AGENDA
WORCESTER TOWNSHIP PLANNING COMMISSION
WORCESTER TOWNSHIP COMMUNITY HALL
1031 VALLEY FORGE ROAD, WORCESTER, PA 19490
THURSDAY, JUNE 22, 2017, 7:30 PM

Reference: Palmer Tract; Preliminary Subdivision Plan
Skippack Pike and Valley Forge Road

CKS Engineers, Inc. is in receipt of a Preliminary Subdivision Plan prepared by Bohler Engineering, for the property at the northeast corner of Skippack Pike and Valley Forge Road in Worcester Township. The preliminary subdivision plan submission consists of a plan set containing four (4) sheets, dated June 16, 2017, with no revisions.

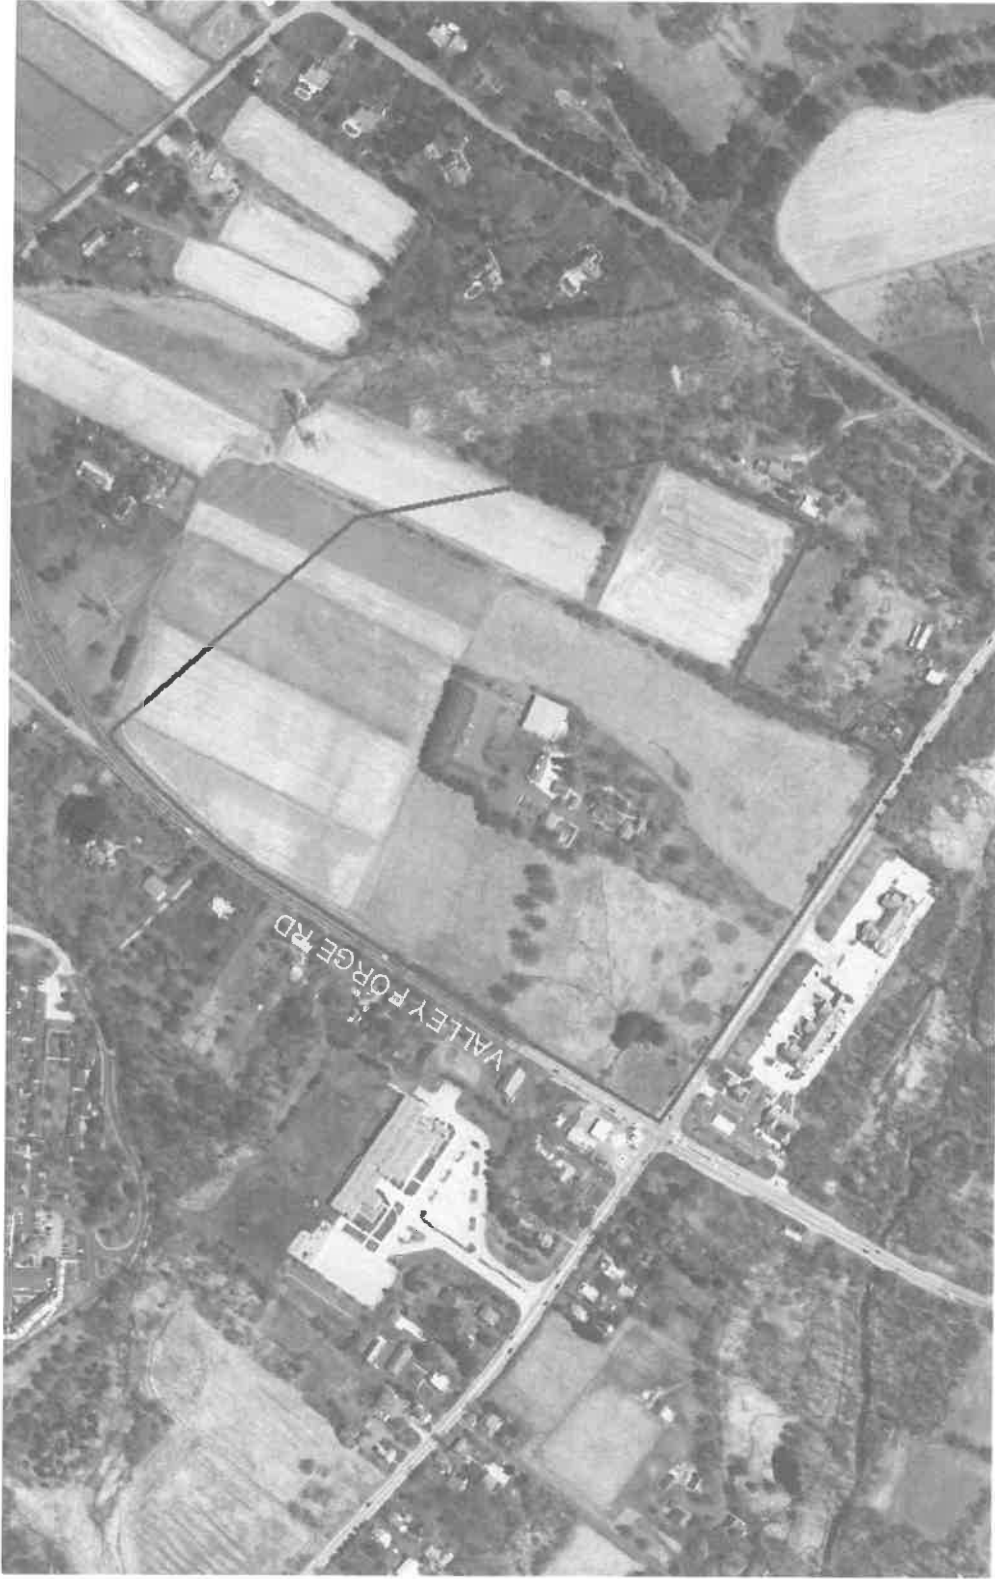
1. The "Site Design Requirements" tabulation on sheet 2 does not identify the natural resource areas that affect the lot area. However, the "Exclusions from Lot Area Calculations" tabulations does itemize the respective resources and their subtraction from the proposed lot areas. For consistency, the exclusions should also be included in the "Site Design Requirements" tabulation.(150-9)
2. The plan proposes a single lot in the LPD district, with no improvements shown. We note that there are significant criteria that the Township may wish to consider discussing with the applicant regarding this lot, such as intended use, i.e. single family dwellings, multifamily dwellings, open space, density and street layout, etc. (150-110.24, 150-110.26).

3. The plan does not include a tabulation of the respective dimensional requirements of the LPD district. In addition, the yard setbacks shown for Lot 8 do not appear to be consistent with the requirements of the district, specifically the "Neighborhood Setbacks"(150-26.A, 150-26.B, 150-110.26.C, 150-199)

4. Zoning Ordinance Section 150-110.26.A.1 requires a yield plan for the LPD lot. We note that no such plan has been submitted.
5. The submission does not include a proposed street and lot layout, which would specifically apply to the parcel/lot proposed in the LPD District. (130-33.E)

6. The plan should be revised to indicate how the water supply and sanitary sewer requirements of the subdivision will be addressed. (130-26, 130-27, 130-31, 150-110.27)

7. The plan should be revised to identify the required parking setback from a single family residential district for the Commercial District lots. (150-117.B)

8. The plan does not identify any landscape buffers on the Commercial District lots. (150-118.C)
9. The submission does not include the requisite Landscape Plan. Included with the landscaping requirements are buffer requirements. As noted above, buffers have not been identified on the plan. (130-28.B, 130-28.E, 130-28.G)

11. The plan does not propose any frontage improvements, i.e. road widening, curbing or sidewalk along Skippack Pike and Valley Forge Road. These improvements should be discussed further with the Township and PennDOT.(130-16.A.6, 130-16.C, 130-18, 130-33.F)

13. The plan does not propose any stormwater management facilities, nor indicate conceptual areas where such facilities could be located. Although we recognize that there is no construction proposed at this time, the natural features of the parcel would result in the stormwater management facilities along the front of each of the proposed commercial lots, which may not be desirable. (130-24.A.6, 130-24.B.4.a, 130-33.H, 150-203, 150-203)

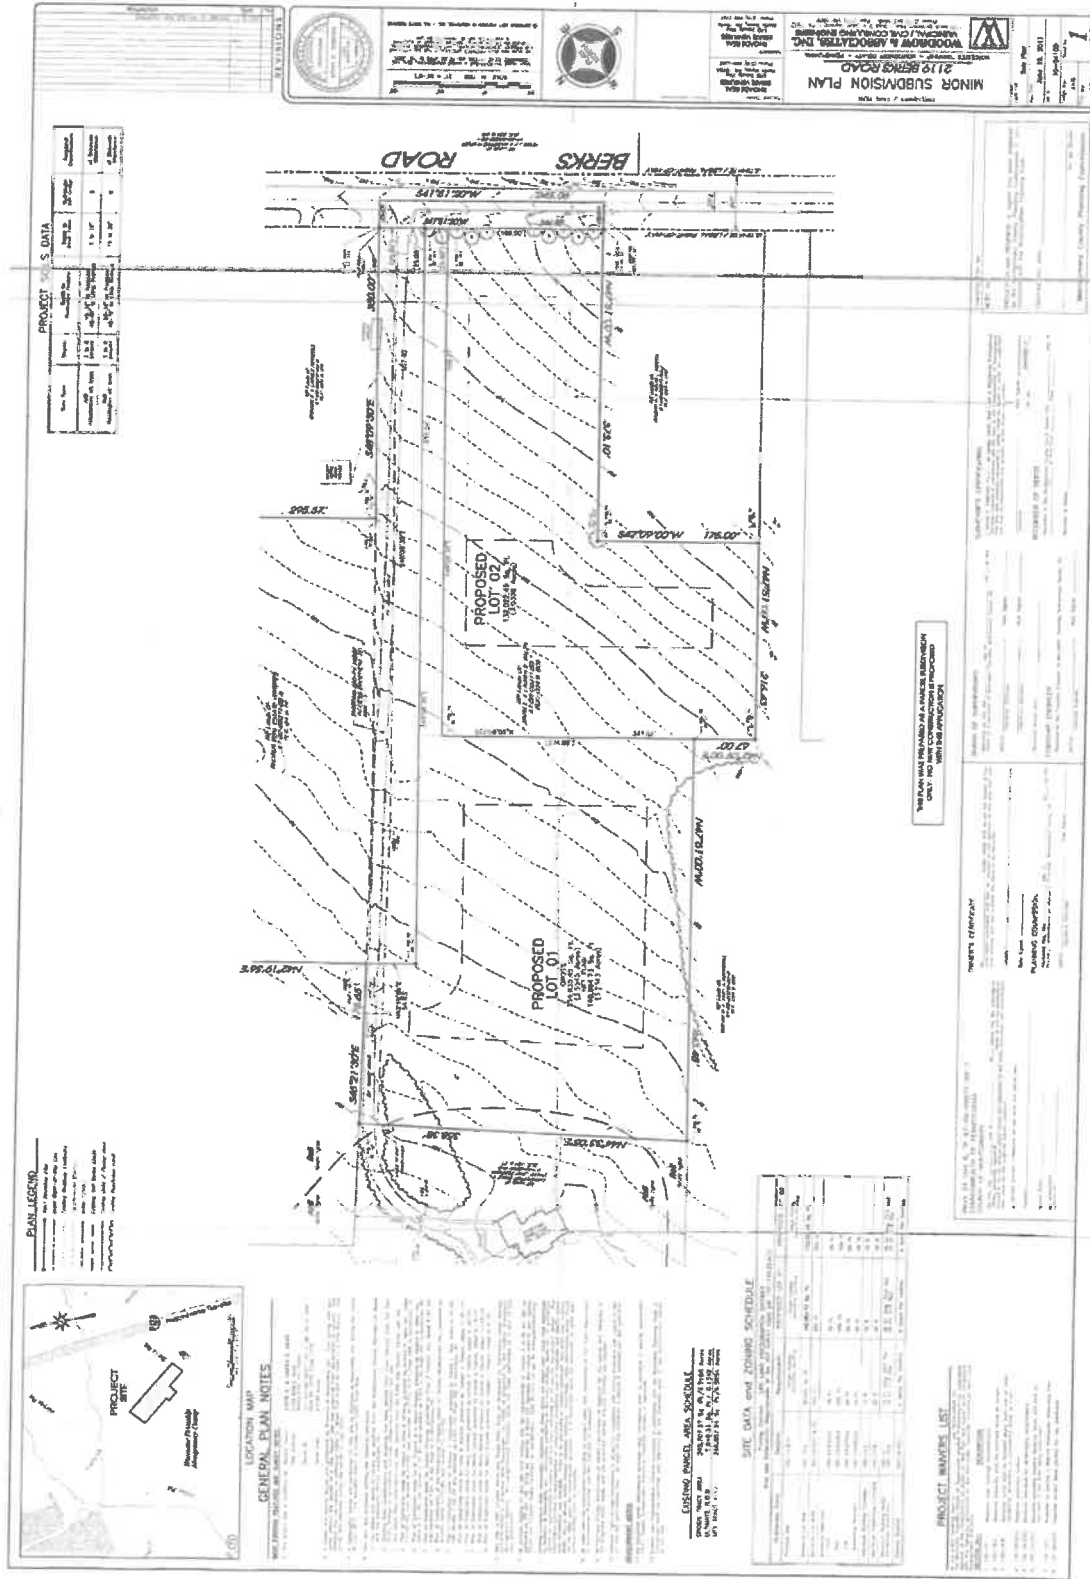
- A. Flag Lots – It appears that the house at 2121 Berks Rd. takes access from the same driveway that these two lots will, as will the two lots 2119 Berks Rd. (North). That is five lots sharing one driveway. This may create potential access issues if all of these lots are developed.

- A. Compliance – This tract is in the LPD Residential District. However, this proposal is for subdivision of a lot less than 8 acres, therefore a Conservation Subdivision or land preservation cluster is not required. This proposal appears to be in compliance with the existing zoning requirements.

LAND DEVELOPMENT PLAN
 SHEET 1
 OF 21
 NWP/PA/17/0112/21

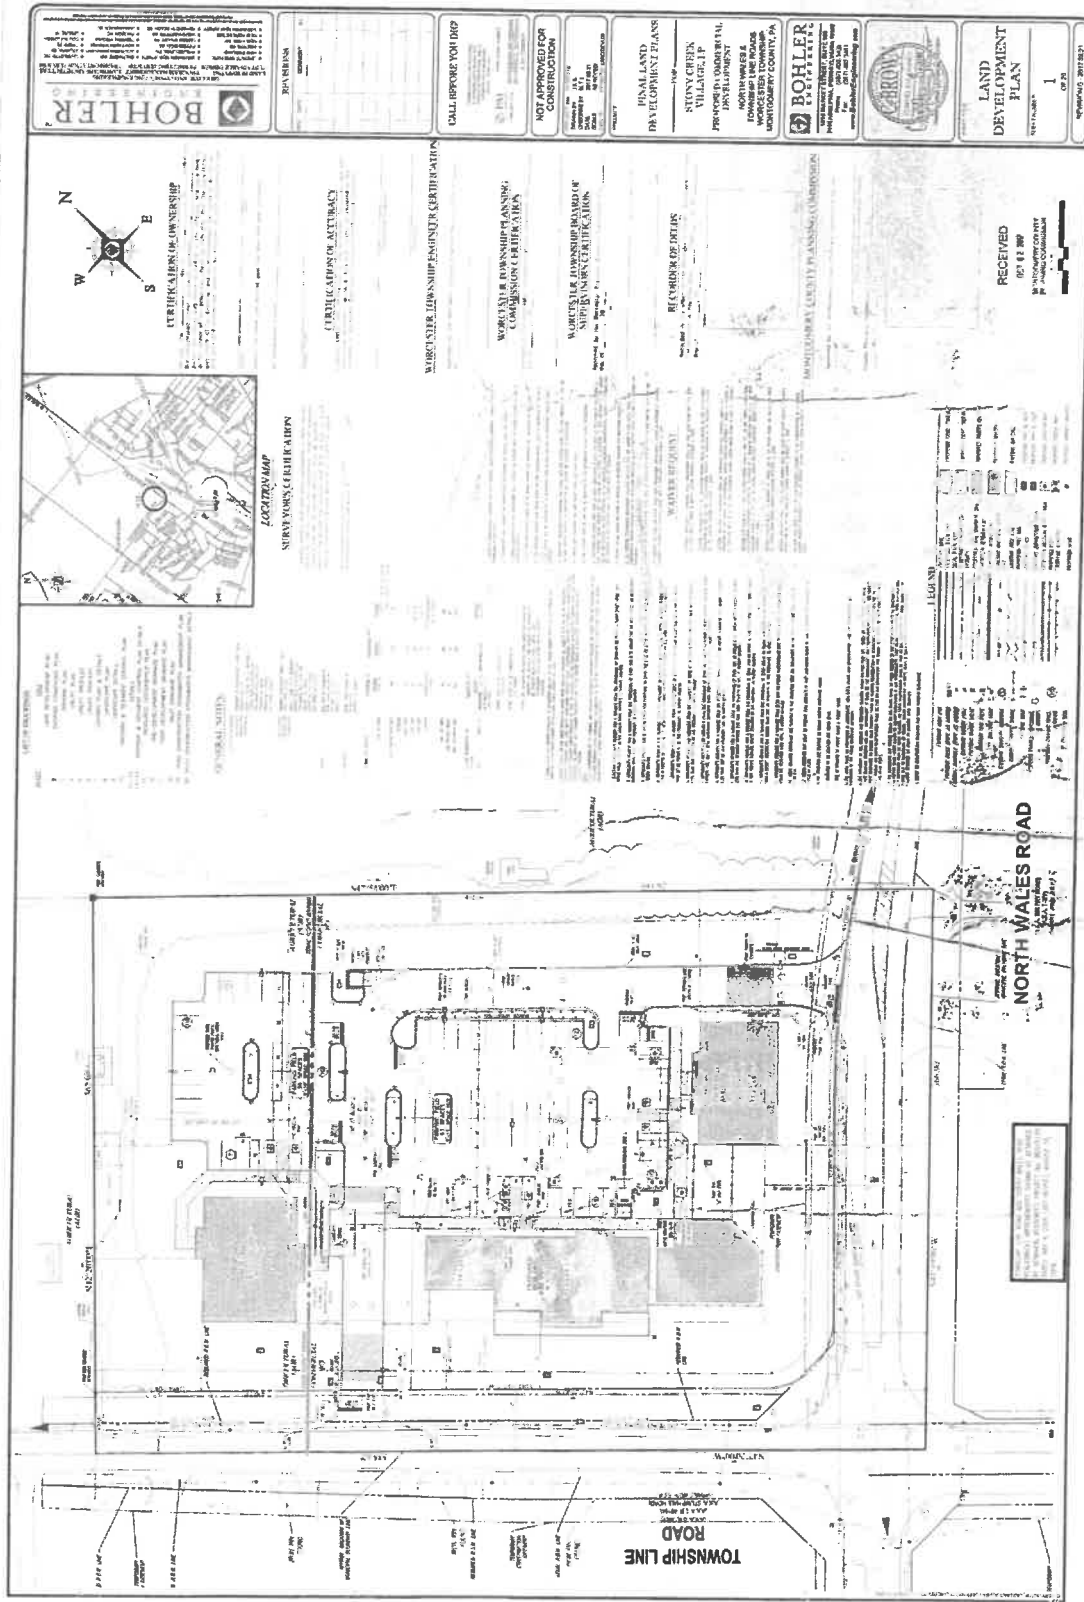
5. The Land Development Plan, sheet 1, shows a 15 ft. trail easement for this project and also a construction of a 6 ft. walking trail within that easement. Metes and Bounds should also be added to the easement and a legal description provided for dedication to Worcester Township.
